Bronco Utah Operations LLC

**RE: Bronco Utah Operations LLC
Emery Mine
DOGM Permit No. C/015/0015
Emery 2 Subsidence Monitoring Plan Revision Resubmittal**

Title: e2 Phase II Subsidence Monitoring Plan Revision

PLATE V-5
SUBSIDENCE MONITORING POINTS AND BUFFER ZONES

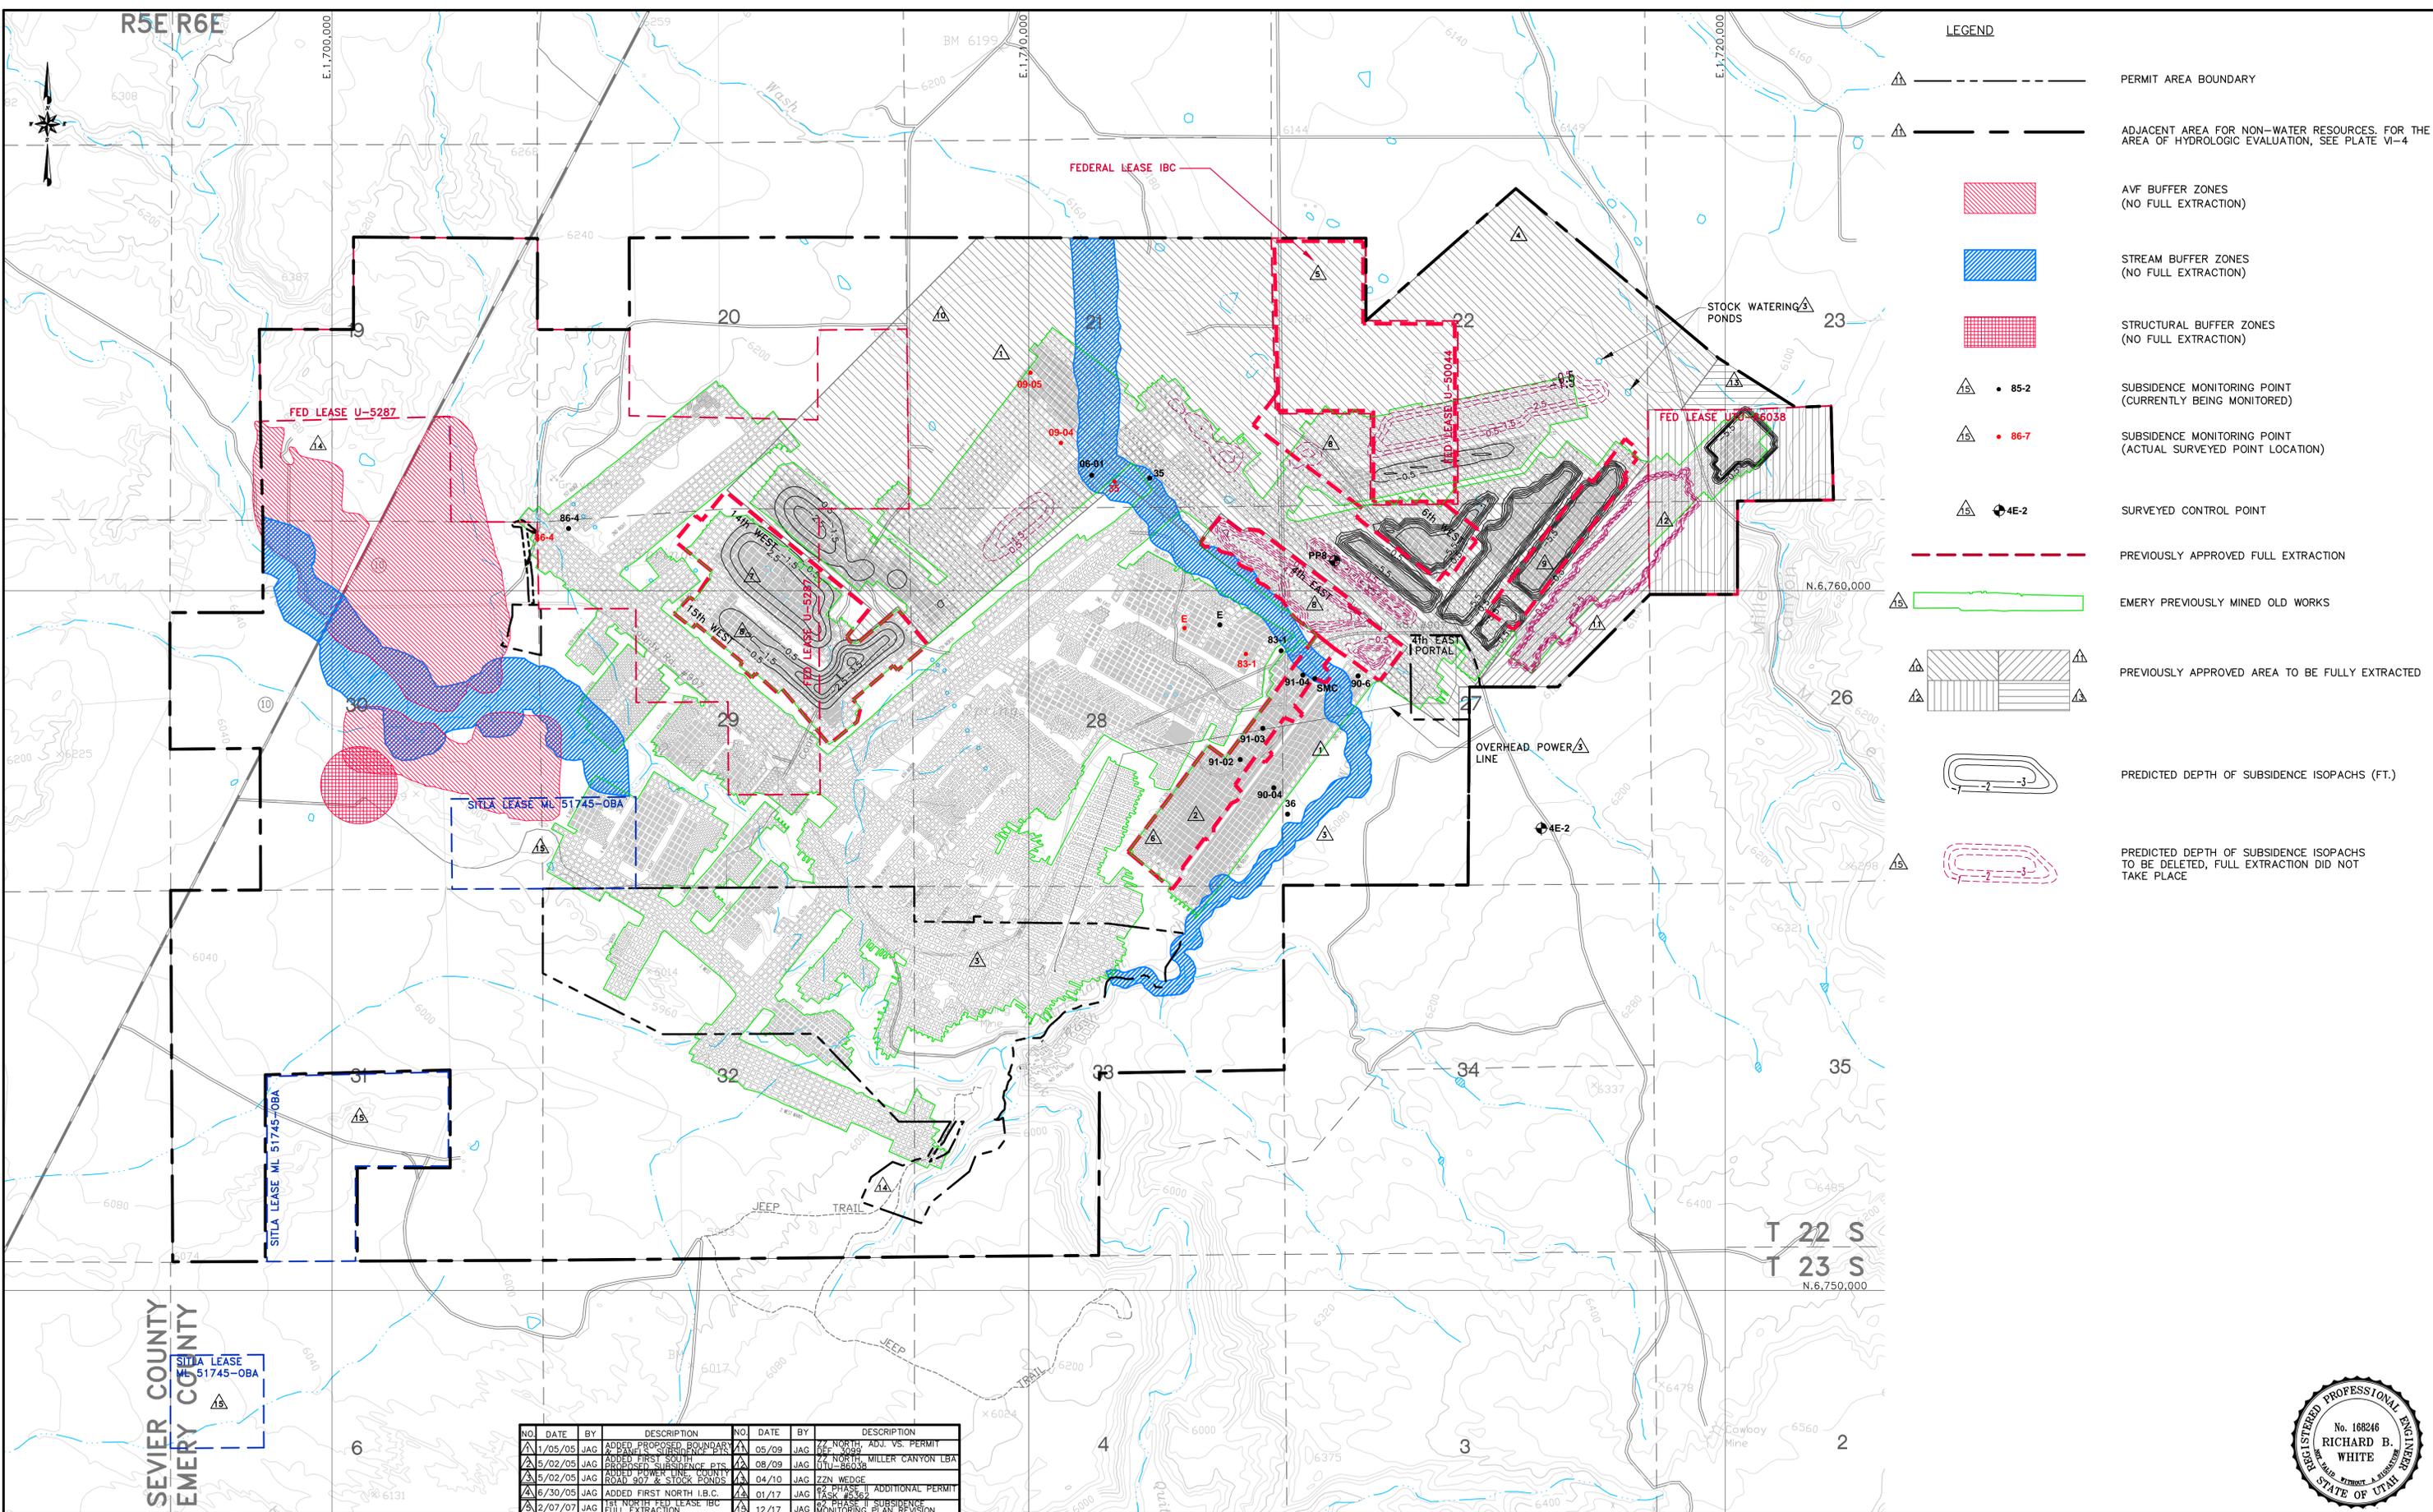
This submittal updates and revises the subsidence monitoring plan. Plate V-5 has been revised to depict active subsidence monitoring points. Plate V-5H has been created to depict historical subsidence monitoring points that will no longer be monitored. Several monitoring points were adjusted on the Plates to reflect their actual field surveyed locations. The proposed subsidence monitoring points that were not set will be removed from Plate V-5. Bronco will submit additional area with a proposed mine plan and proposed subsidence monitoring points once this submittal is approved.

After historical review of the subsidence survey data included in the annual report, Bronco is proposing to discontinue monitoring of the points that have not experienced movement over the past 10 years. Supporting survey data can be found in the 2016 Annual Report.

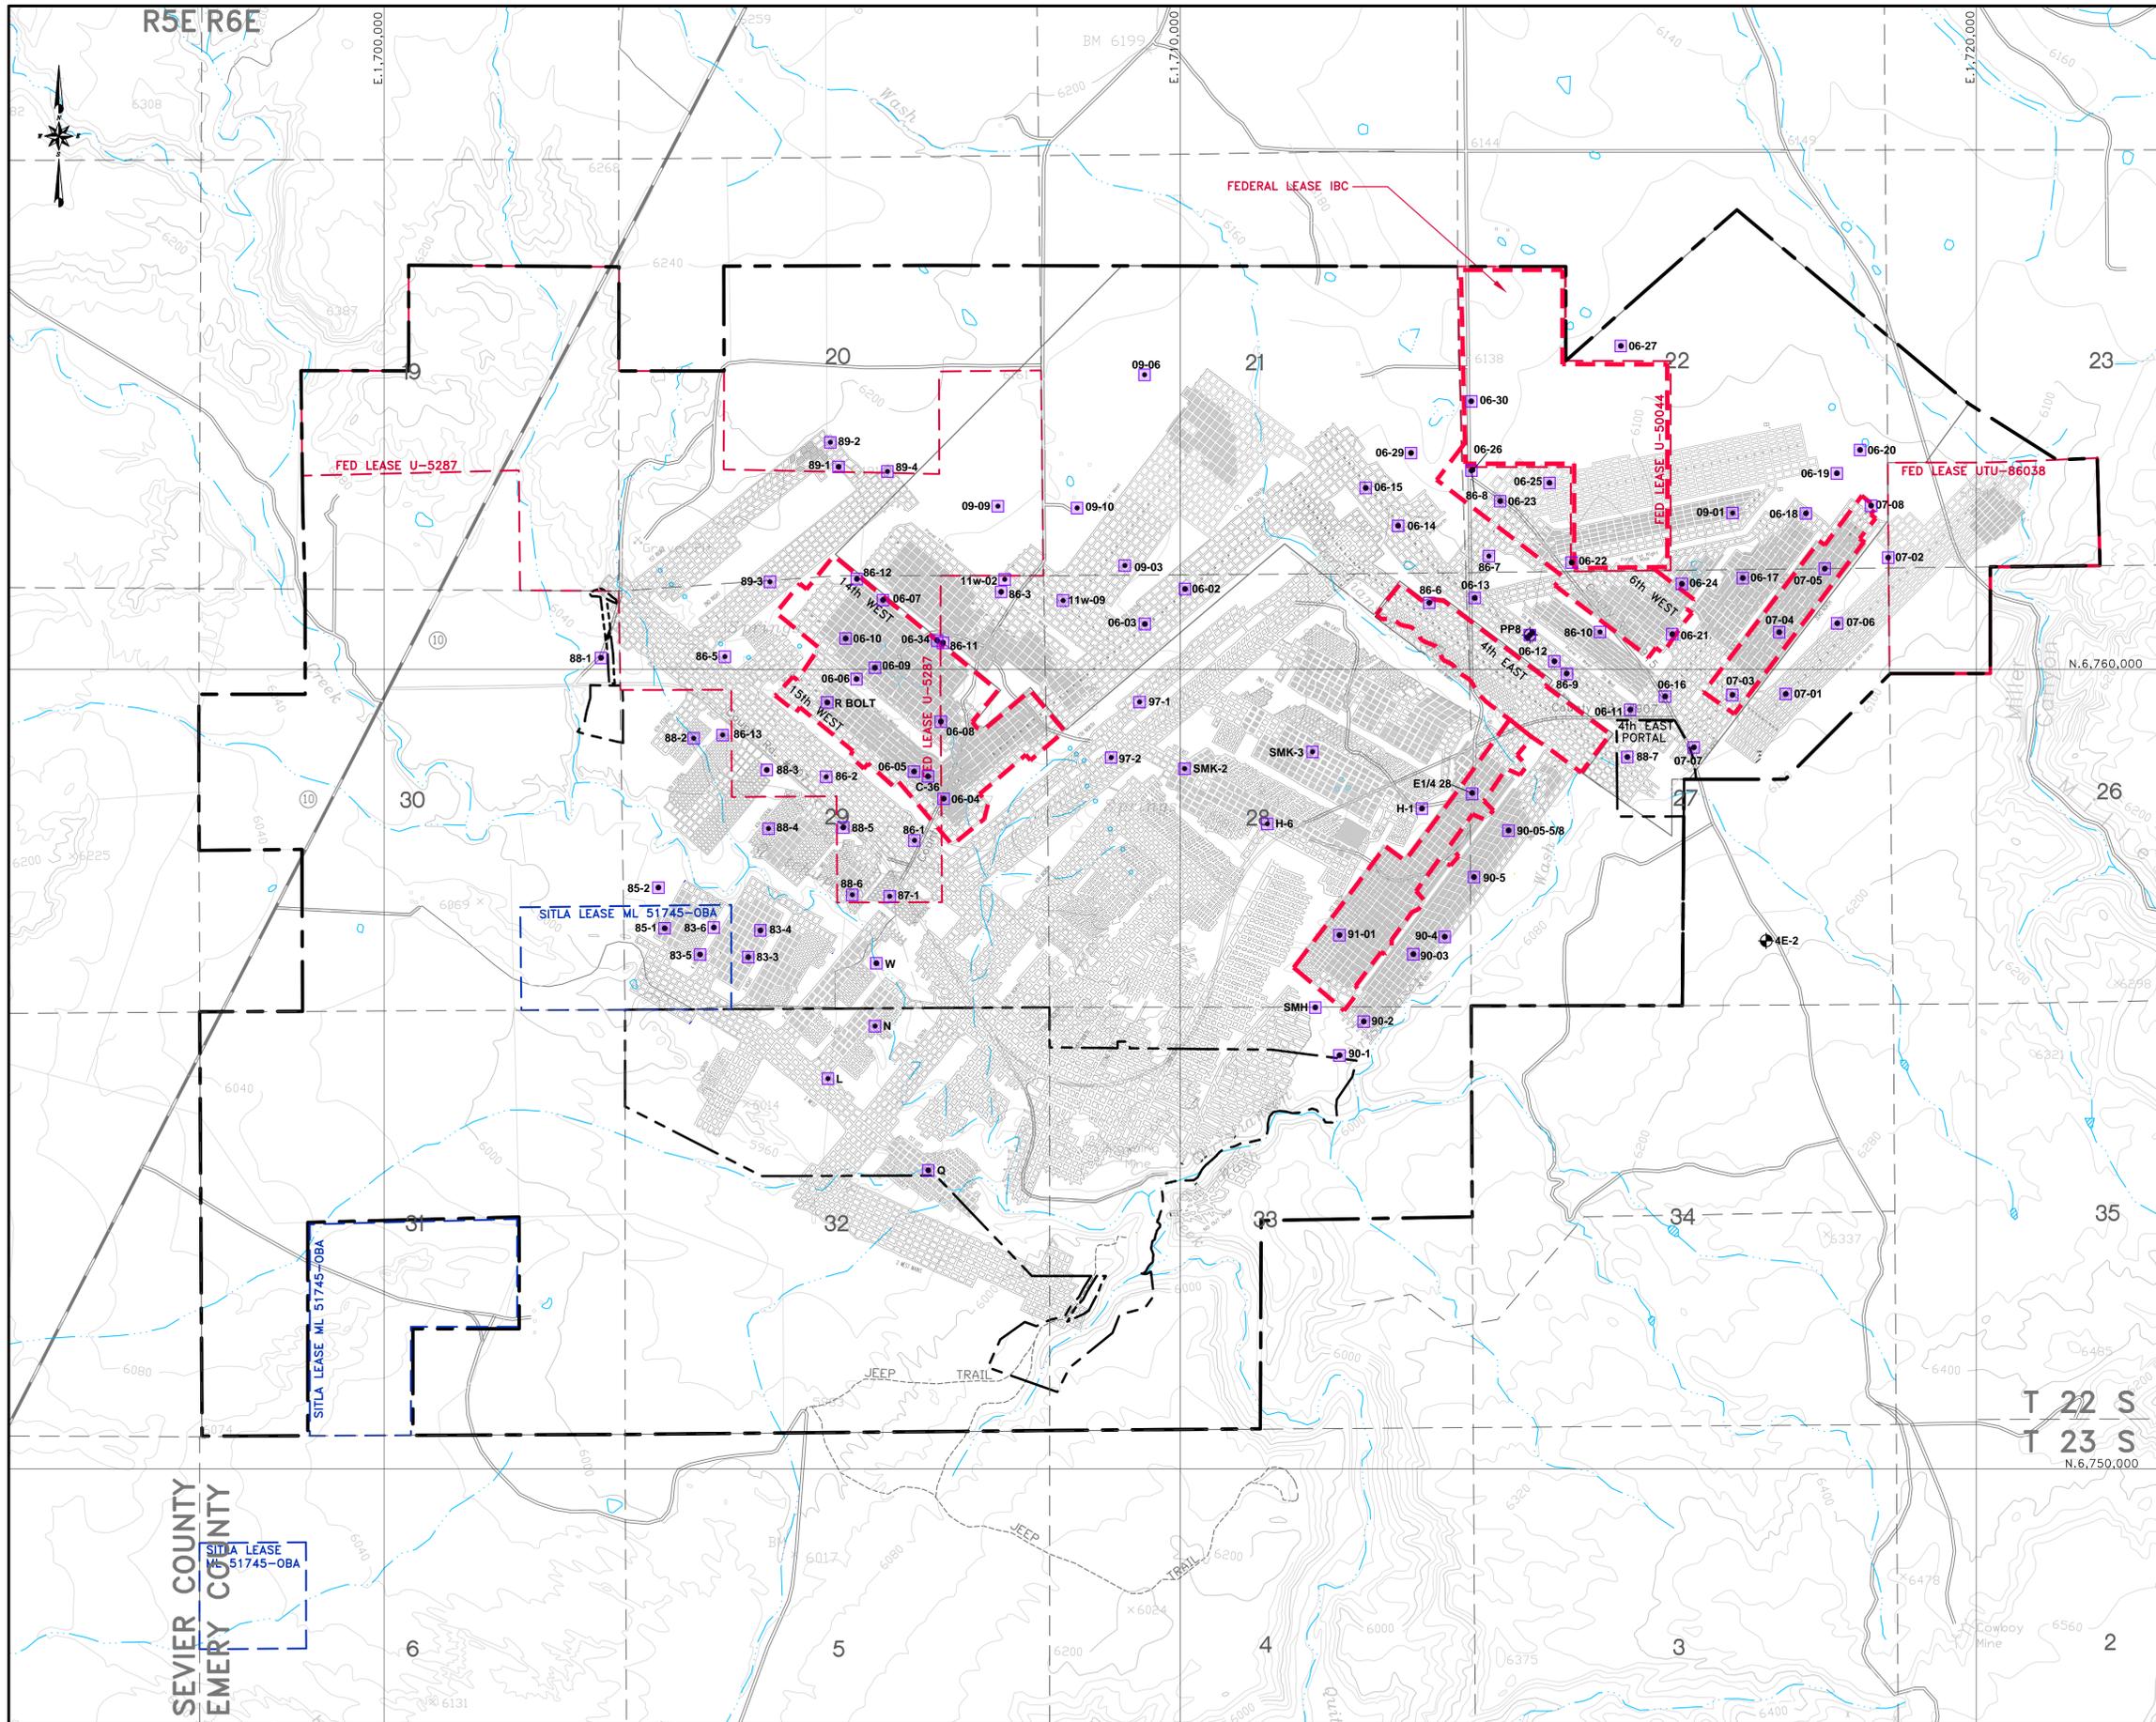
Subsidence monitoring at the Emery mine has been ongoing since the early 1980s. Monitoring points were surveyed and depicted on Plate V-5 (Subsidence Monitoring Points and Buffer Zones). The survey data is submitted via the Annual Report in spreadsheet format. The monitoring points that no longer require a survey can be found on Plate V-5H (Historical Subsidence Monitoring Points). The 2016 Annual Report contains 10 years of historical survey data which supports discontinuing monitoring of these points due to less than 0.1 feet of movement.
